Adamstown Station District Centre, Co Dublin  
Masterplan - Phase III - Blocks A, C & D

DESIGN STATEMENT Blocks A, C & D  
REQUEST FOR FURTHER INFORMATION | SEPTEMBER 2022

Reg. Ref: SDZ22A/0005

BLOCK D GROUND FLOOR PLAN - PLANNING

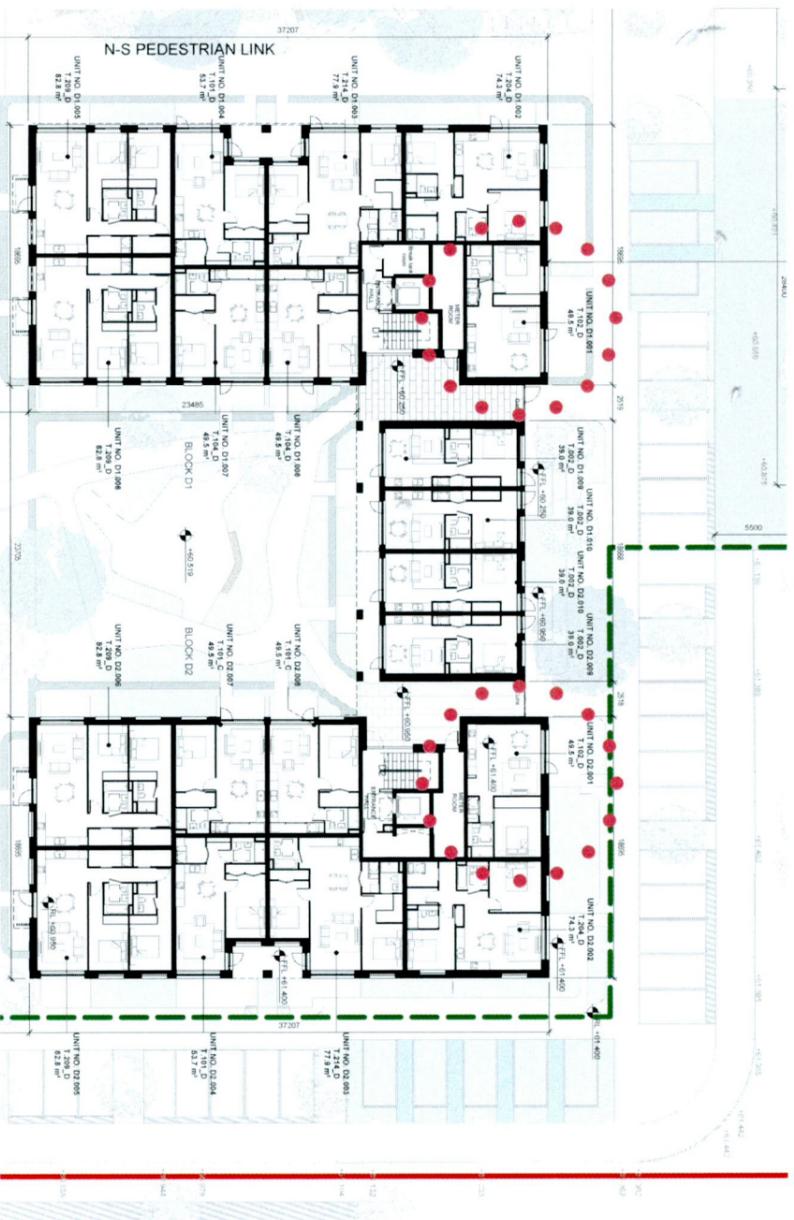
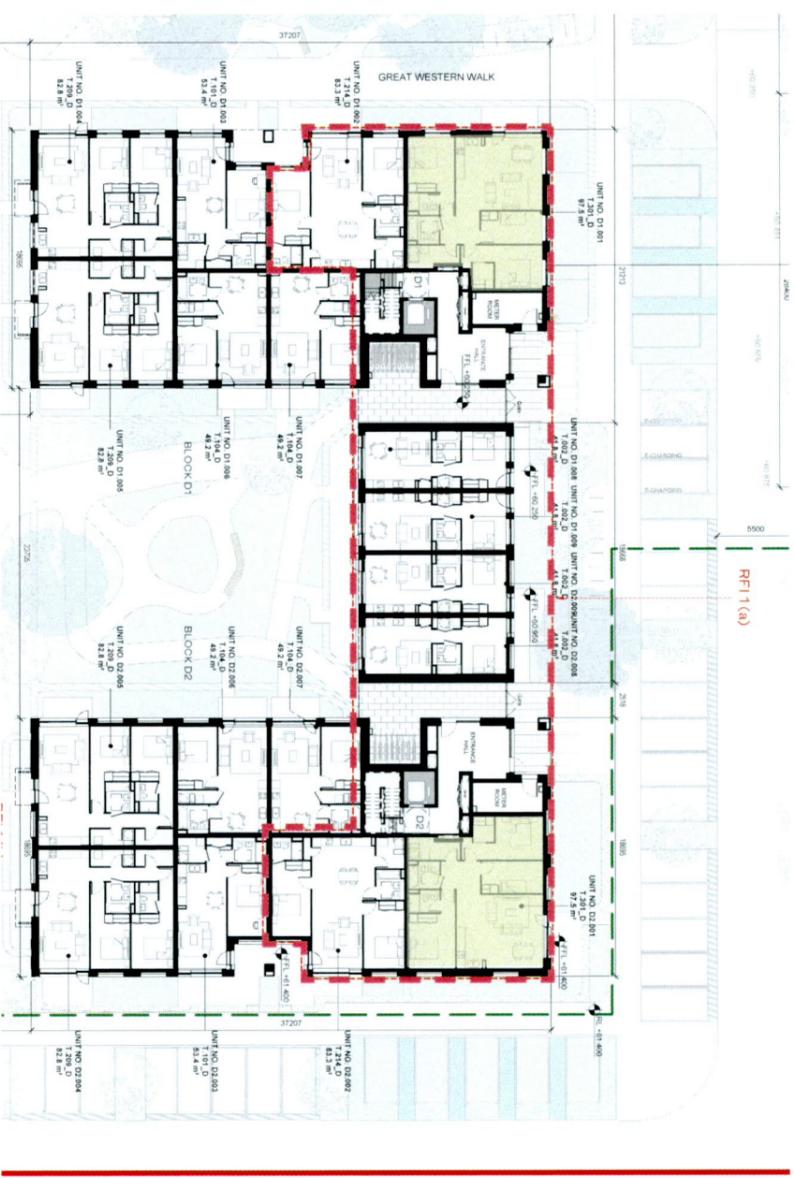
*(a) The following apartments are north facing and single aspect, however, the Housing Quality Assessment states that they are dual aspect: D1.001 (T.102\_D) D2.002 (T.102\_D) These units front onto Great Western Way and it is not apparent that they overlook any significant amenity areas directly. The applicant is, therefore, requested to submit a separate schedule and plan indicating all single aspect north facing apartment detailing compliance with Paragraph 3.18 of the Apartment Guidelines. Any single aspect north facing apartments that do not meet the requirements of the Apartment Guidelines should be omitted. Any resultant change in the percentage of overall dual aspect apartments should also be set out.*

UNIT TYPE T.102\_D THE SUBJECT OF RFI NO.1 (A)

NOTE: GROUND FLOOR LEVEL SHOWED A WINDOW TO THESE UNITS BUT IT WASN'T EVIDENT IN THE PLANNING DRAWINGS

Block D North  
Design and layout changes to the Core D1 & D2 and to the entrance hall facing Great Western Way updated to accommodate new apartment type T.301\_D at Ground Floor and revised apartment type T.102\_D as dual aspect unit on the Upper Floors.

BLOCK D GROUND FLOOR PLAN - RFI PROPOSAL

THE PREVIOUS TWO UNITS, T.102\_D AT GROUND FLOOR HAVE BEEN OMITTED. THE PREVIOUS UNIT TYPE OF T.204\_D HAS BEEN REVISED TO CREATE A NEW UNIT TYPE OF T.301\_D (HIGHLIGHTED IN YELLOW) FOLLOWING THE ENTRANCE CORE DESIGN CHANGES, UNIT TYPE T.214\_D FOOTPRINT AMENDED AS A RESULT THE FACADE HAS BEEN SETBACK BY 2.6M TO ALLOW FOR GREATER WINDOW DEPTH ON THE UPPER FLOORS. PREVIOUS DEPTH OF SET BACK WAS 1.6 M

T.102\_D - PLANNING

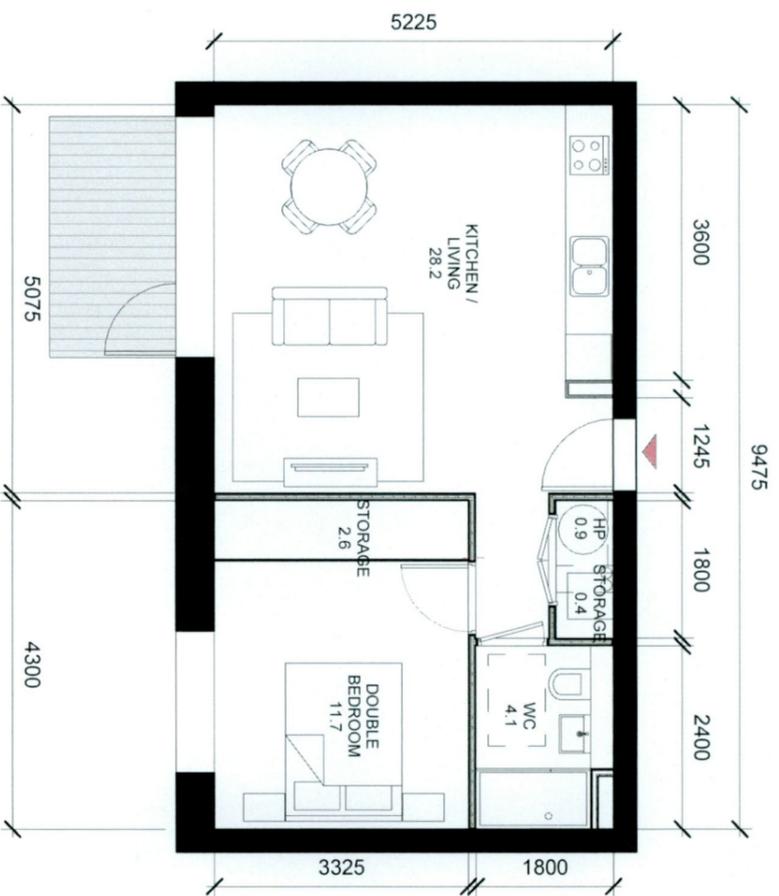
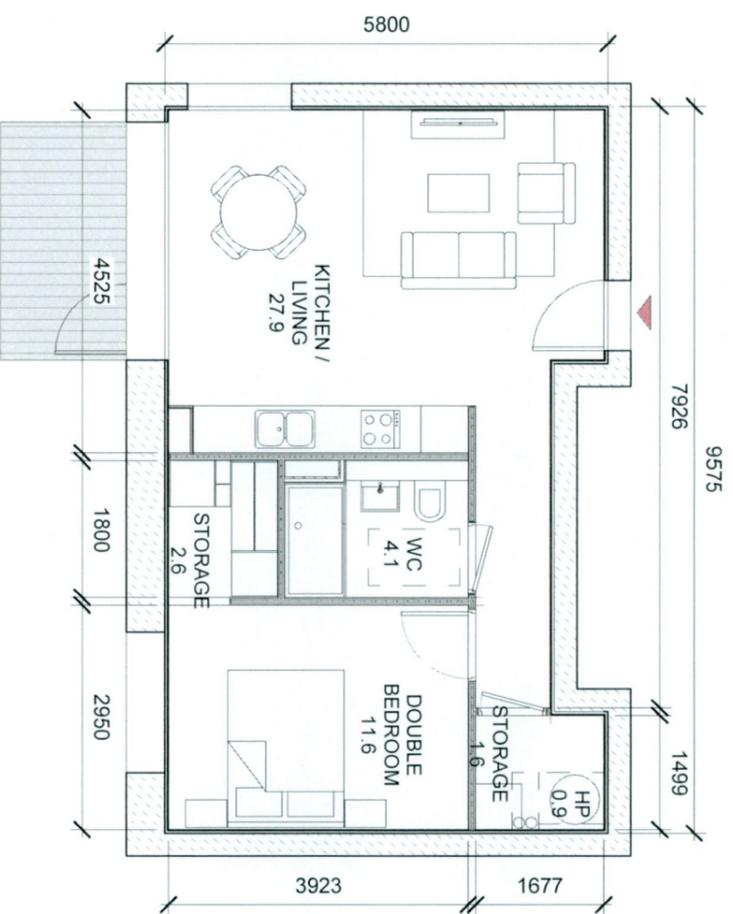
1. (a) The following apartments are north facing and single aspect, however, the Housing Quality Assessment states that they are dual aspect:  
D1.001 (T.102\_D)  
D2.002 (T.102\_D)

APT D1.001 & D2.002 IS T.102\_D - HOA STATES THE UNIT IS DUAL ASPECT - REFER TO DRAWING P8002, T.102\_D

T.102_D SPACE REQUIREMENTS																									
Apartment Area	50.7 m <sup>2</sup>	Required Apartment Area	45.0 m <sup>2</sup>	Required Area Met	Yes	Kitchen - Living Area	27.9 m <sup>2</sup>	Required Kitchen - Living Area	23.0 m <sup>2</sup>	Required Area Met	Yes	Total Bedroom Area	11.6 m <sup>2</sup>	Required Total Bedroom Area	11.4 m <sup>2</sup>	Required Area Met	Yes	Total Storage Area	4.2 m <sup>2</sup>	Required Total Storage Area	3.0 m <sup>2</sup>	Required Area Met	Yes	Heat Pump Area	0.9 m <sup>2</sup>

BLOCK D GROUND FLOOR PLAN - PLANNING

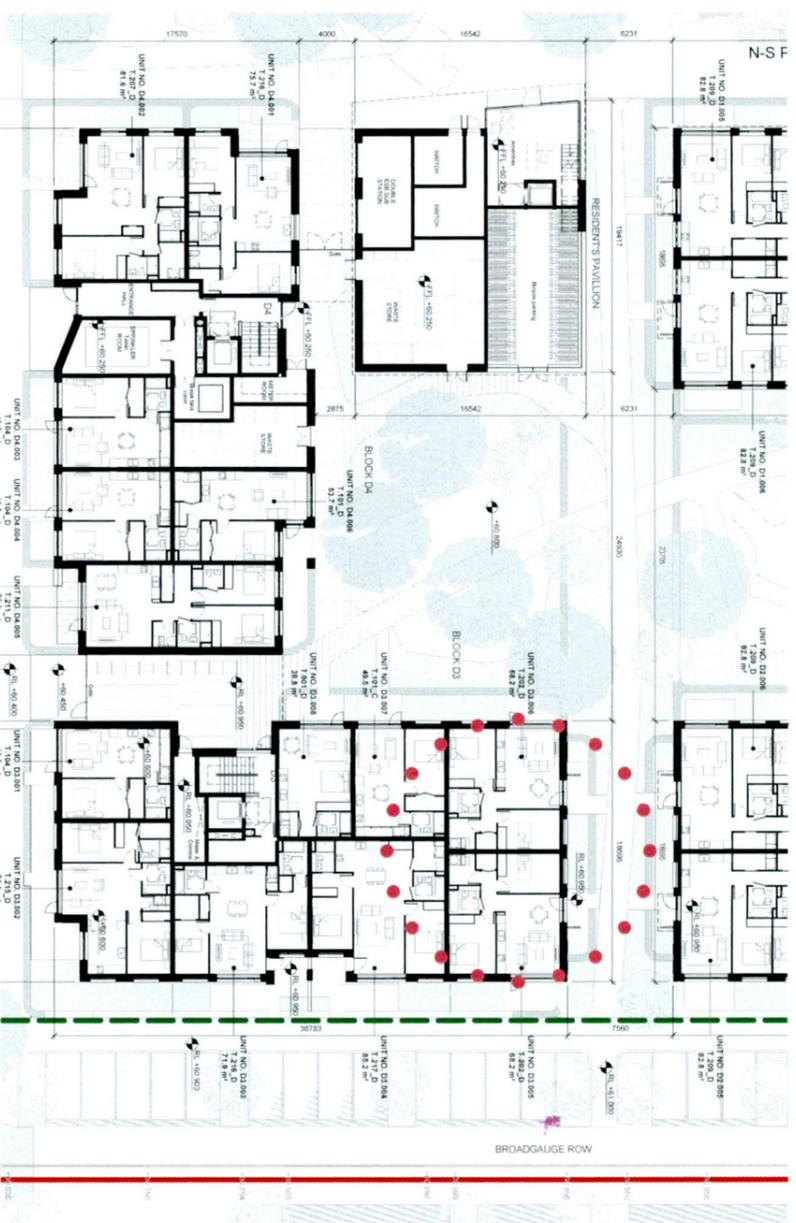
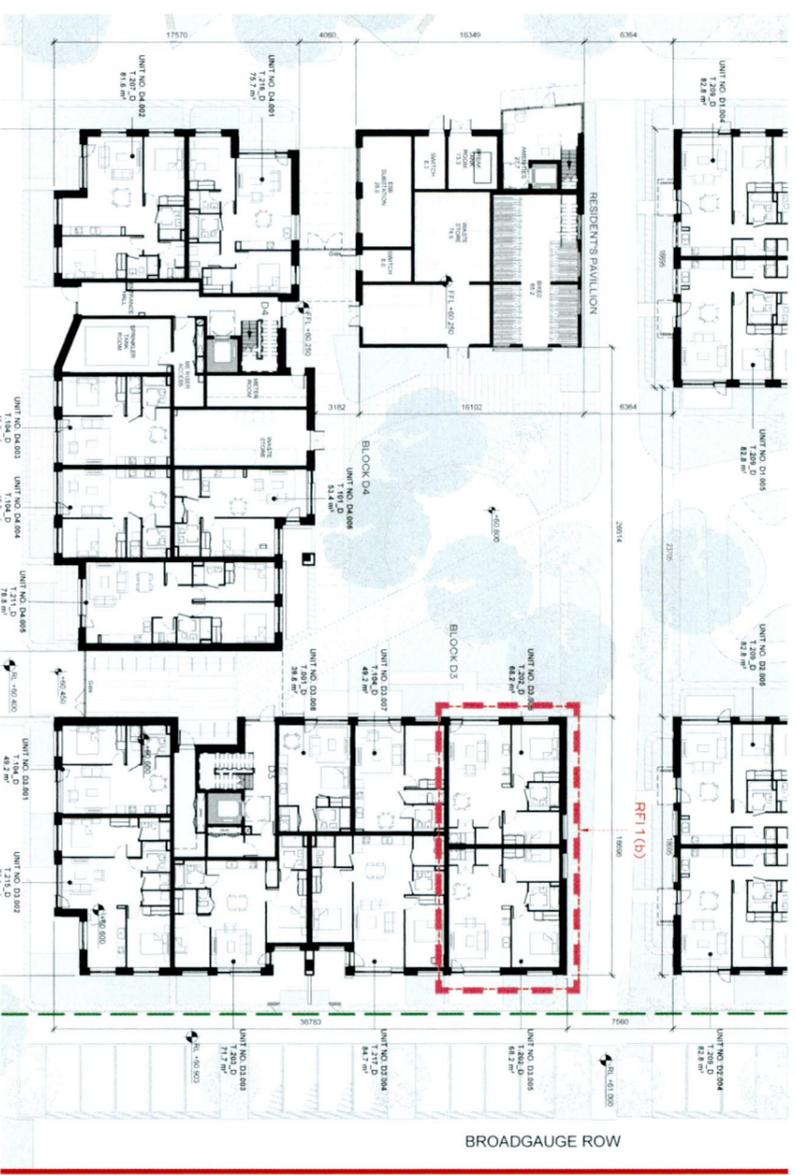
*(b) In general, a good degree of separation is maintained. The exception to this is Blocks D2 and D3, where the separation distance between opposing windows is 7.77m. The Planning Authority is concerned that the living spaces are provided at the closest points, therefore increasing the risk of overlooking. Given the proximity of the apartment in D2 and D3, it would be preferable for the living spaces to be reorientated so bedrooms / bathrooms were opposing rather than living rooms. The applicant is requested to provide a rationale for the proposal or consider revised plans indicating the reorganisation as set out above.*

UNIT TYPE T.202\_D THE SUBJECT OF RFI NO.1(B)

Block D South  
Design and layout changes to apartment type T.202\_D on Ground Floor and T.201\_D on the Upper Floors to overcome privacy issues between Blocks D2 & D3.  
Apartment type T.202\_D living spaces reorientated to minimize overlooking concern between Blocks D2 & D3

INTERNAL RECONFIGURATION OF LIVING ROOM TO THE SOUTH OF THE UNIT AND BEDROOMS RELOCATED TO THE NORTH AND REMOVAL OF WINDOW TO THE NORTH FAÇADE TO AVOID OVERLOOKING

### BLOCK D TYPICAL FLOOR PLAN - PLANNING

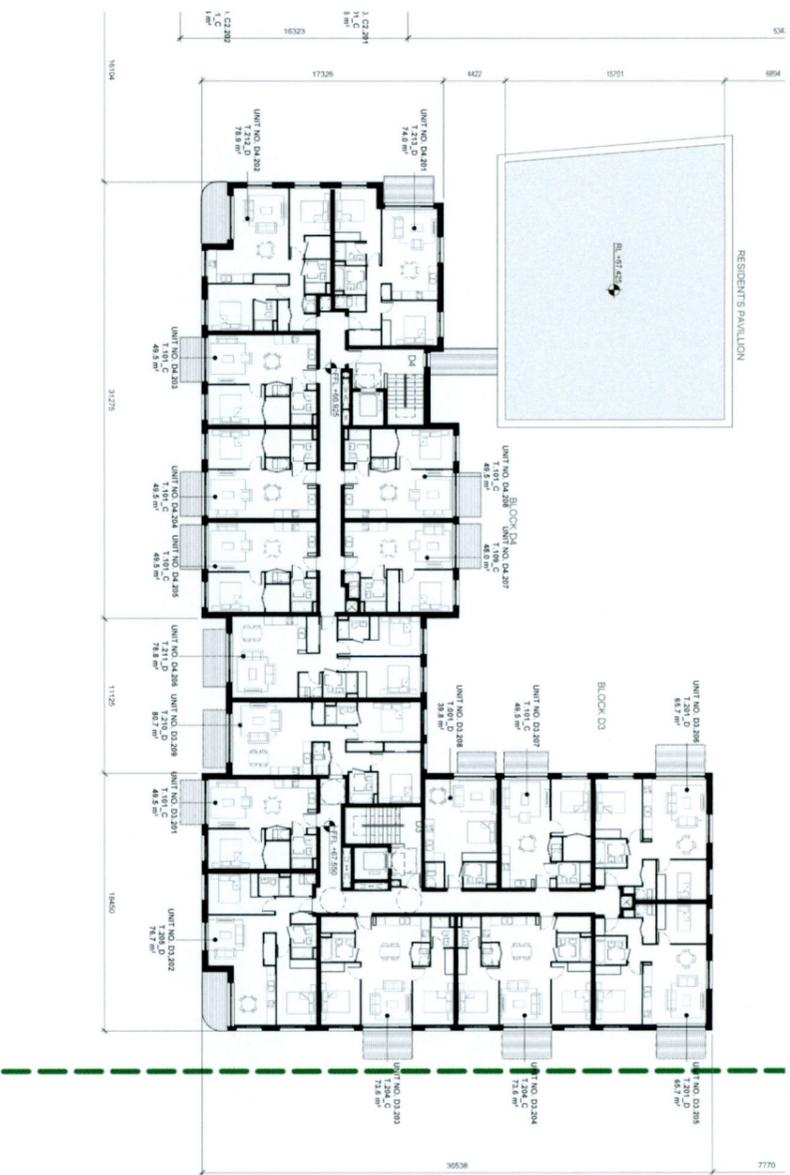
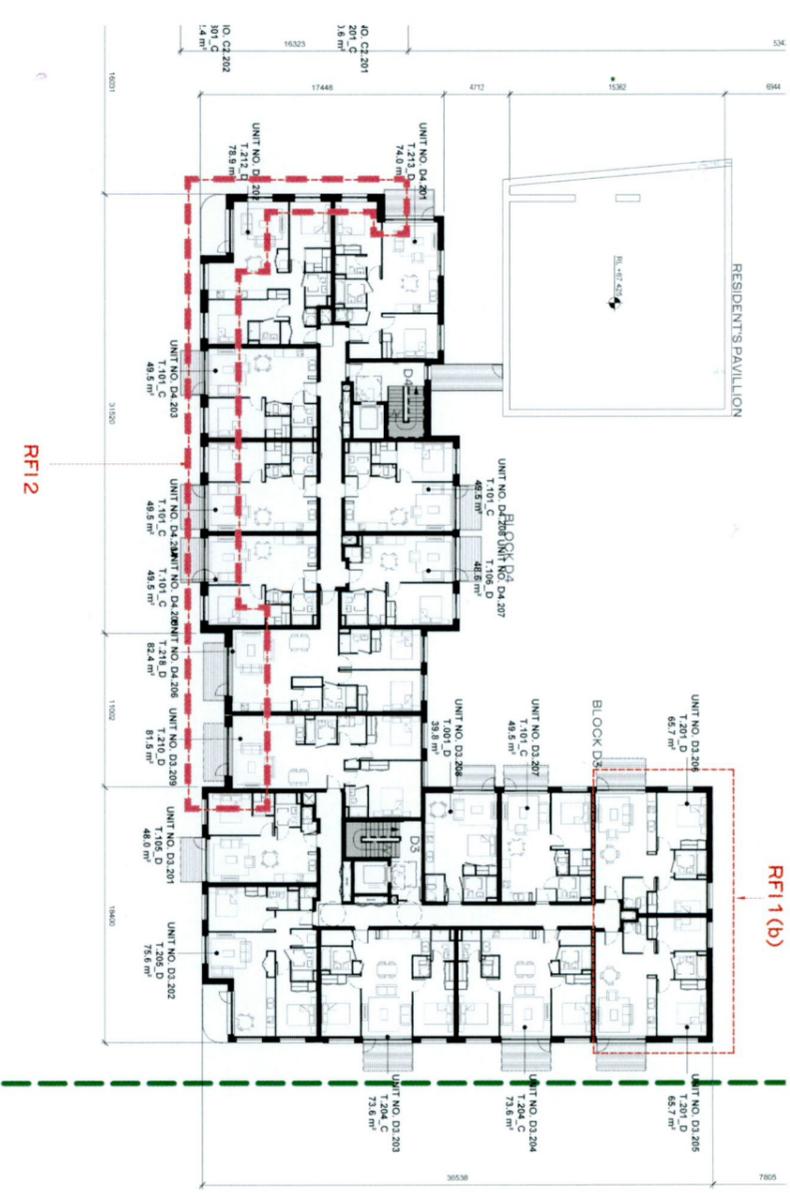
*The materials and finishes proposed for Blocks A, C and D are considered generally acceptable. However, it is noted that render is provided along Station Road, and it is considered that, given the prominence of this location, brick should be provided. The applicant is requested to provide details of revised materials along Station Road frontages.*

Block D South  
Design revised to replace Block D render facade material with brick along Station Road. Brick introduced to the facade on Block D upper floor levels.

**RFI 2**  
 BLOCK D SOUTH - CHANGES TO FACADE MATERIAL TO BRICK ON  
 THE UPPER FLOOR LEVELS
